BIDDING ADDENDUM No. 3 PLAN SET

BAIRD ISD WELDING ACADEMY

REVISIONS:	
No.	Date
1	ADDENDUM 3 9/2/2021
CIVIL SITE LAYOUT PLAN	
C02	
© WRA Architects, Inc. 2020

CIVIL DETAILS 3

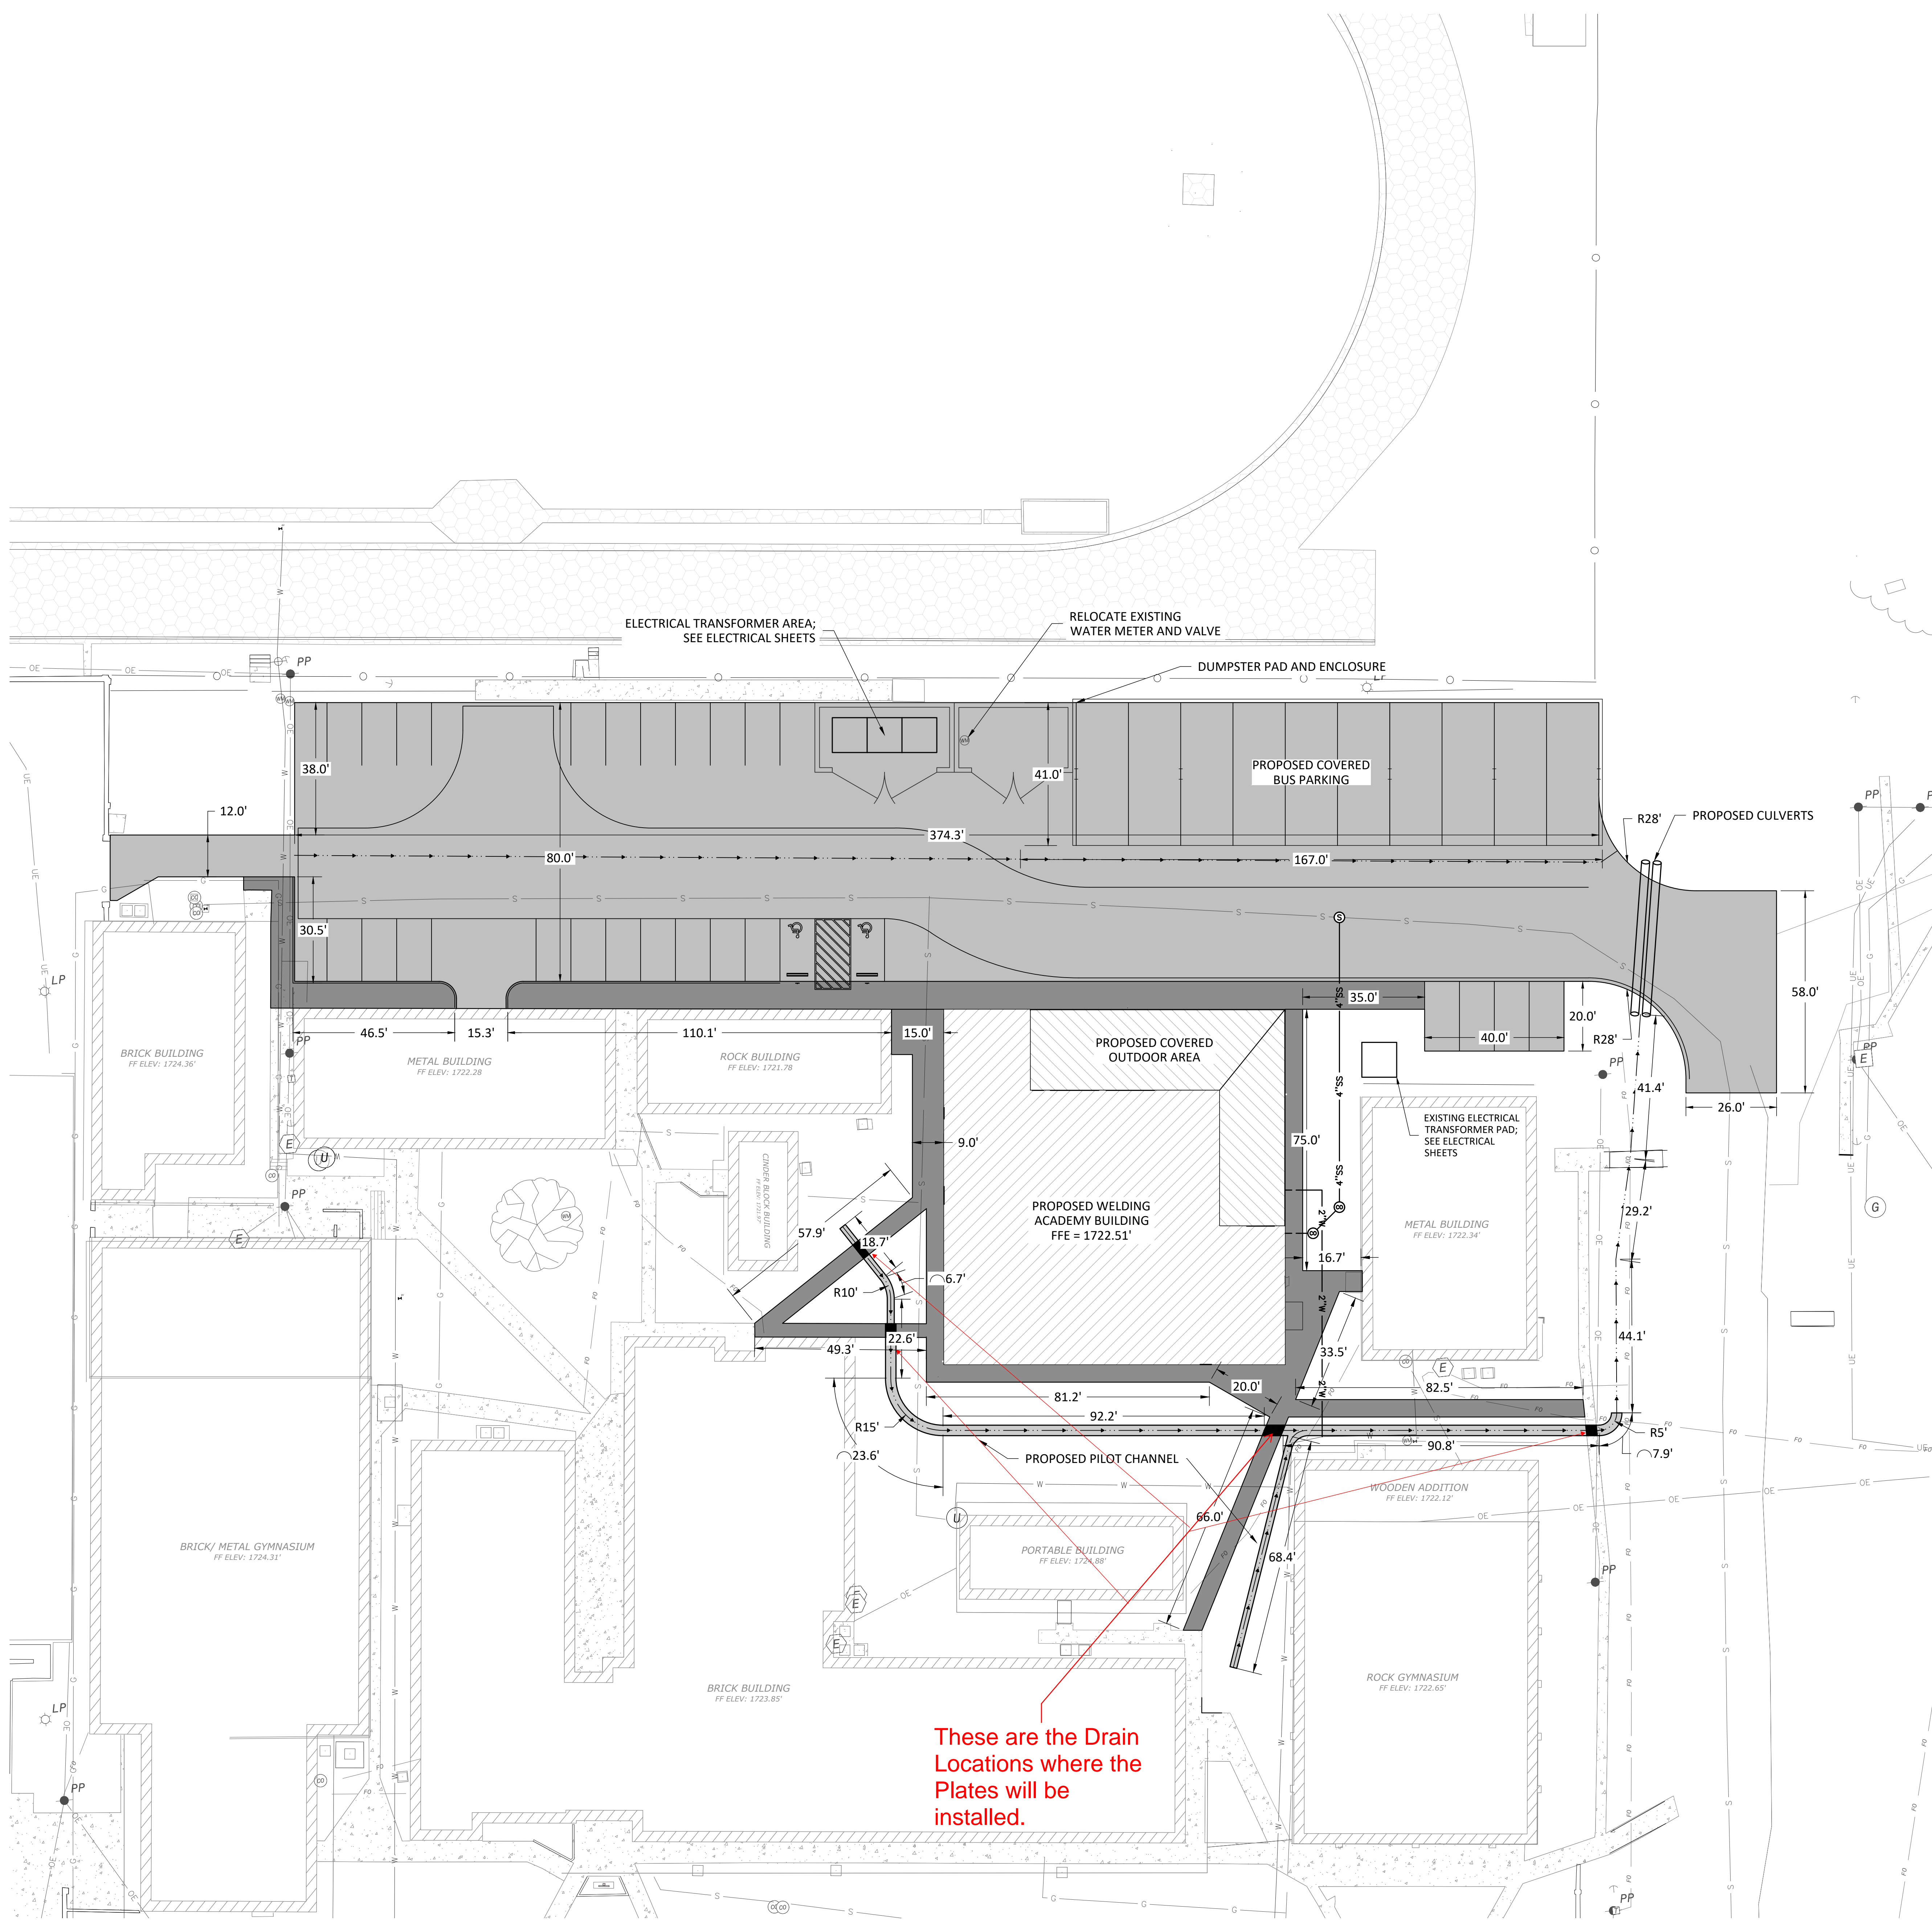
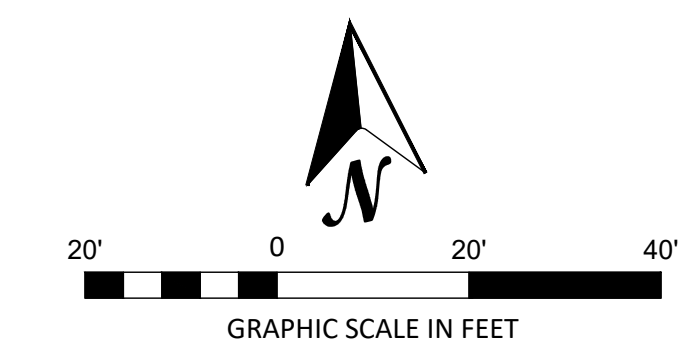
These are the Drain Locations where the Plates will be installed.

1 SIDEWALK DRAIN DETAILS
N.T.S.

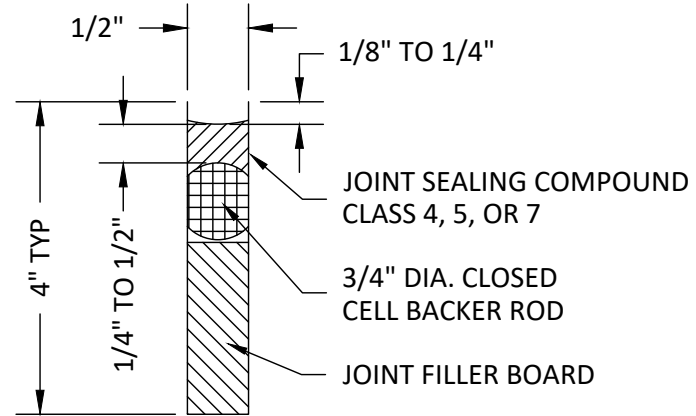
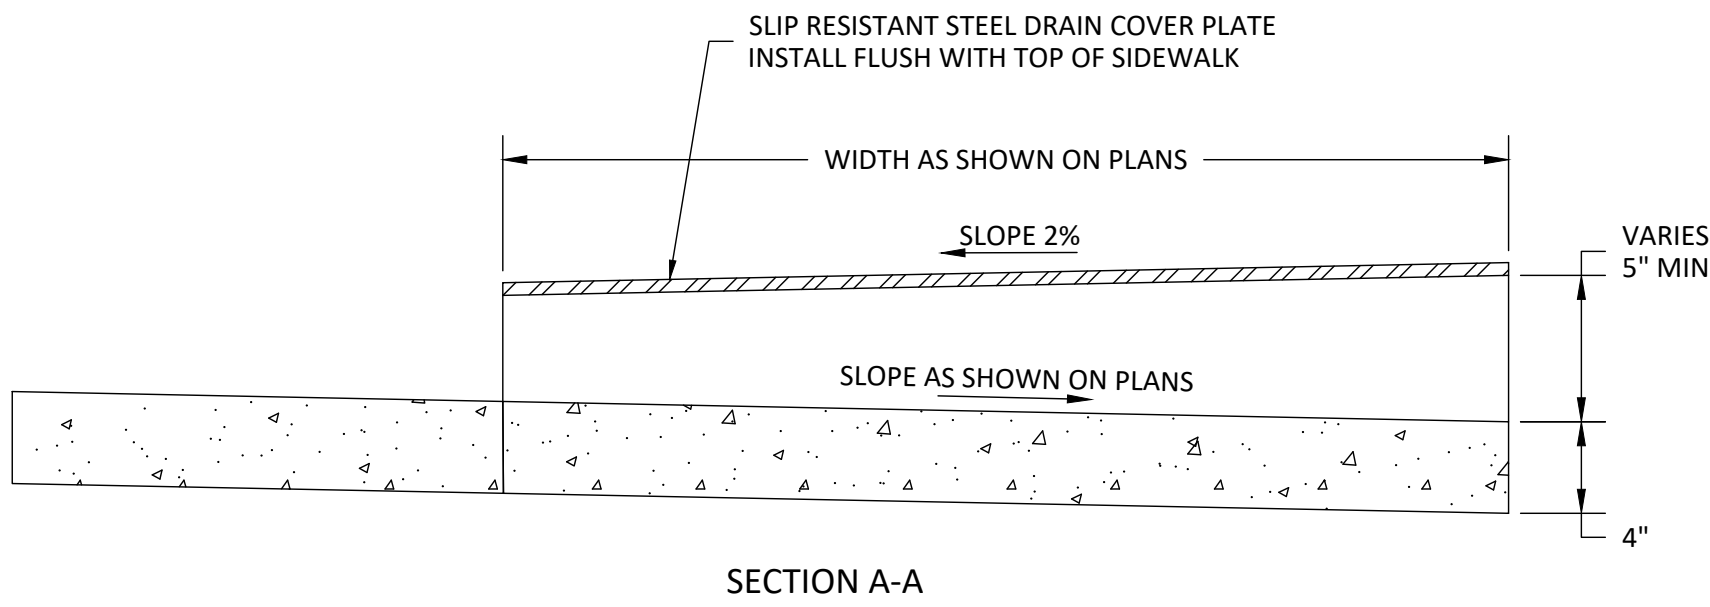
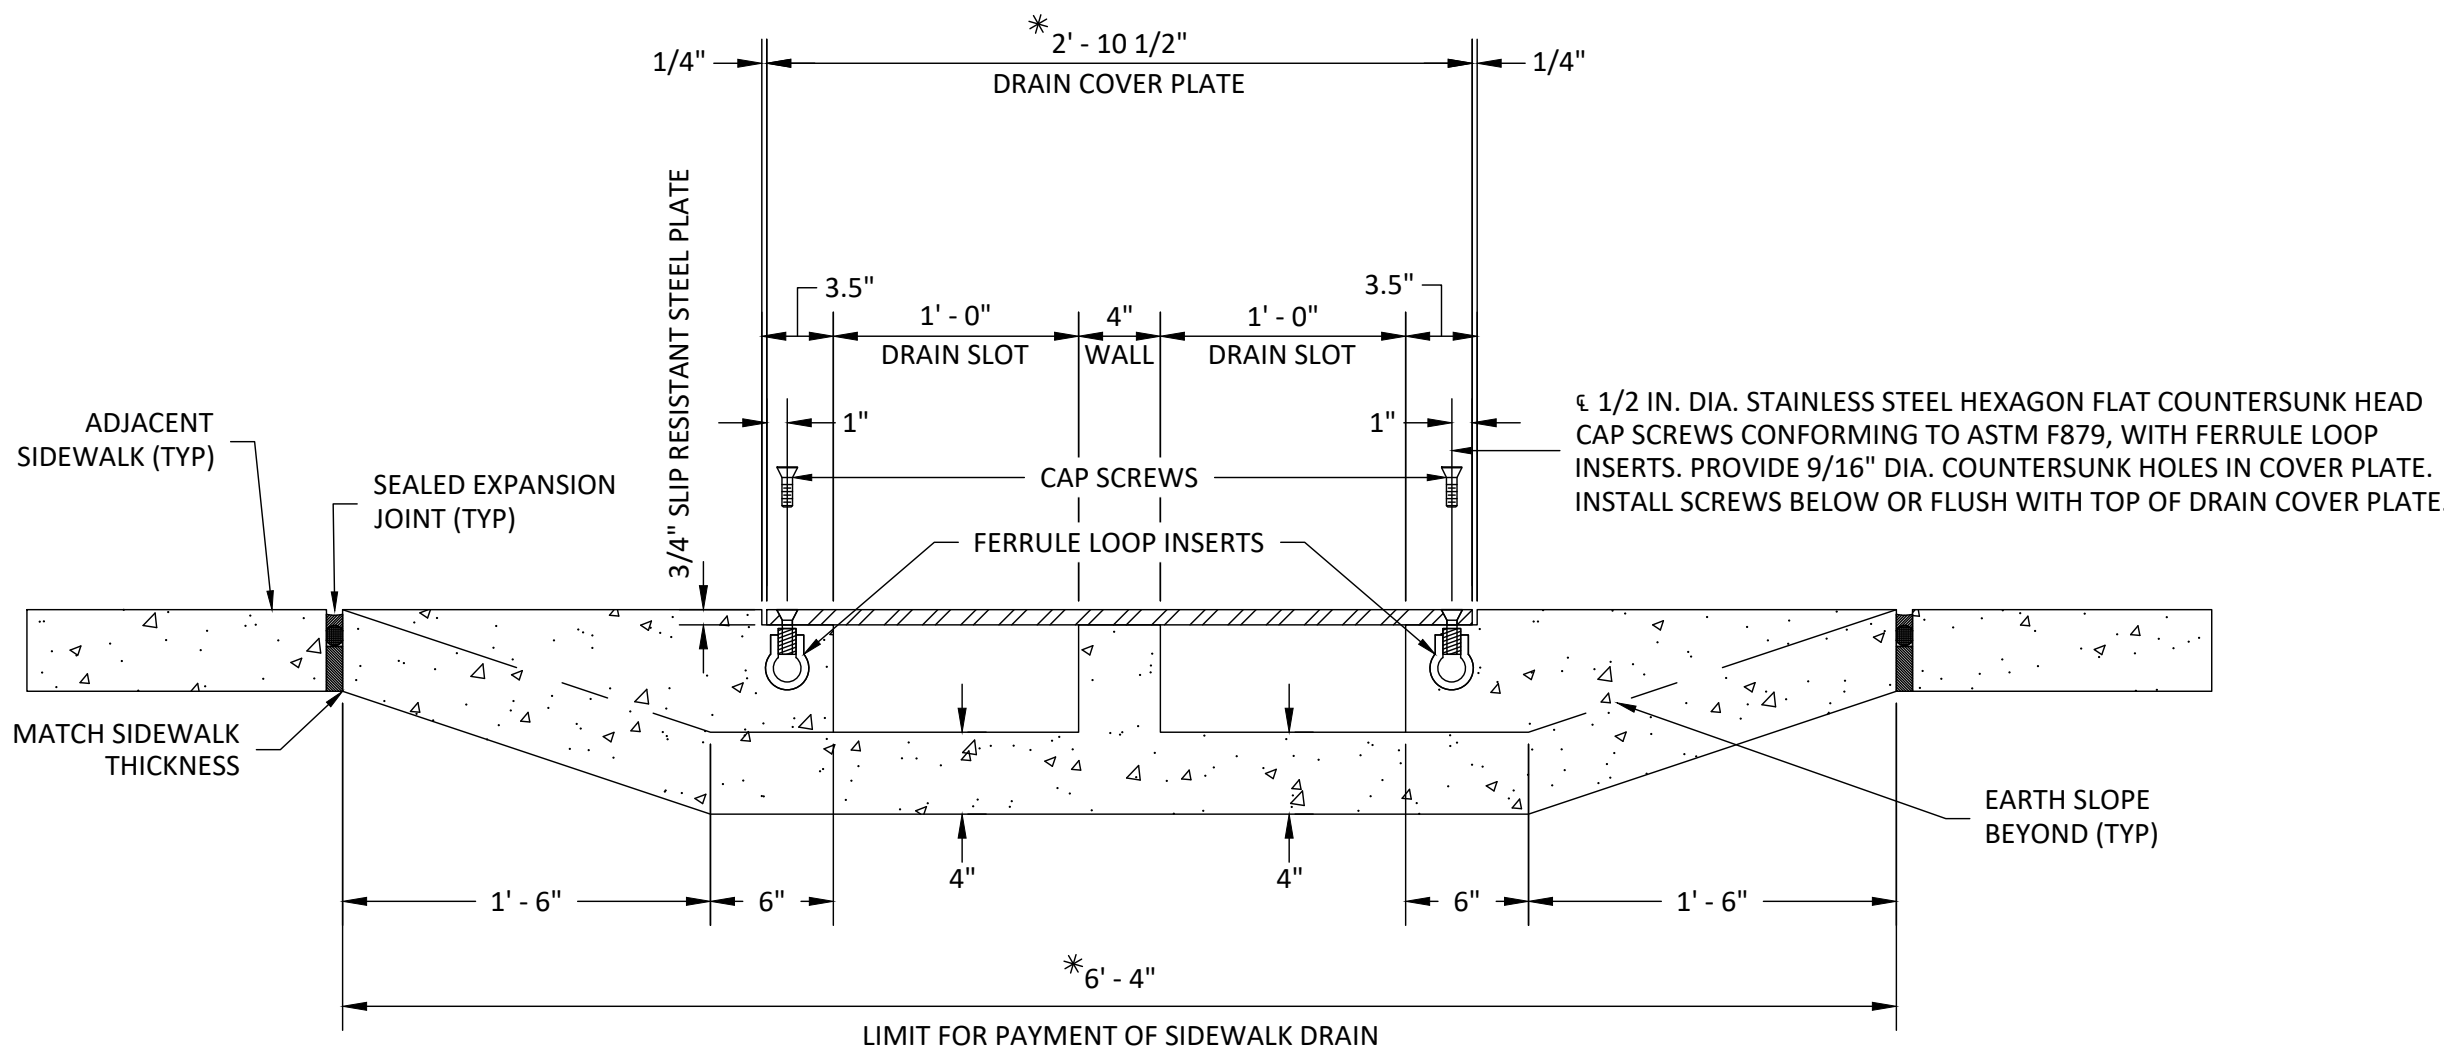
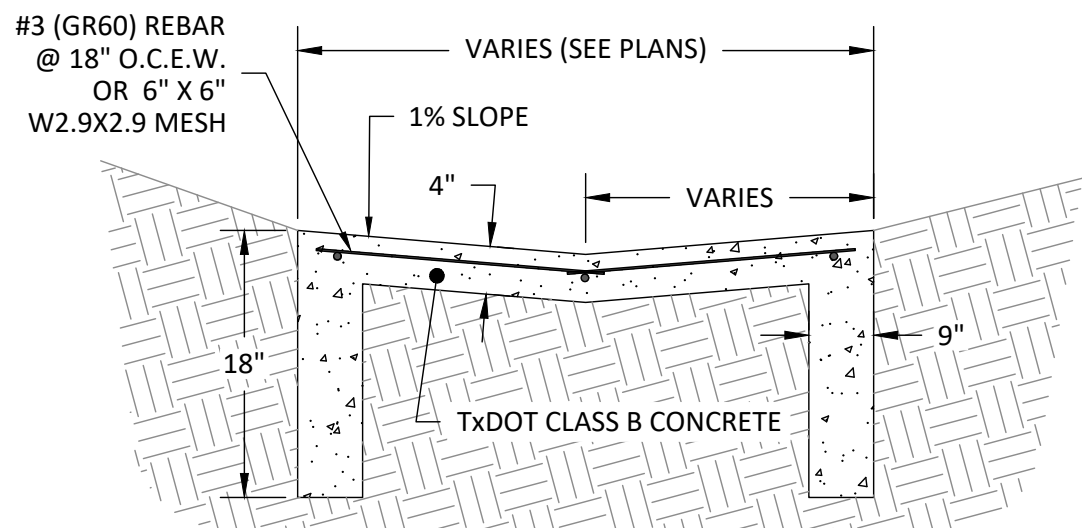
* NOTE:
INCREASE OR DECREASE 1' - 4" FOR EACH
DRAIN SLOT ADDED OR REMOVED
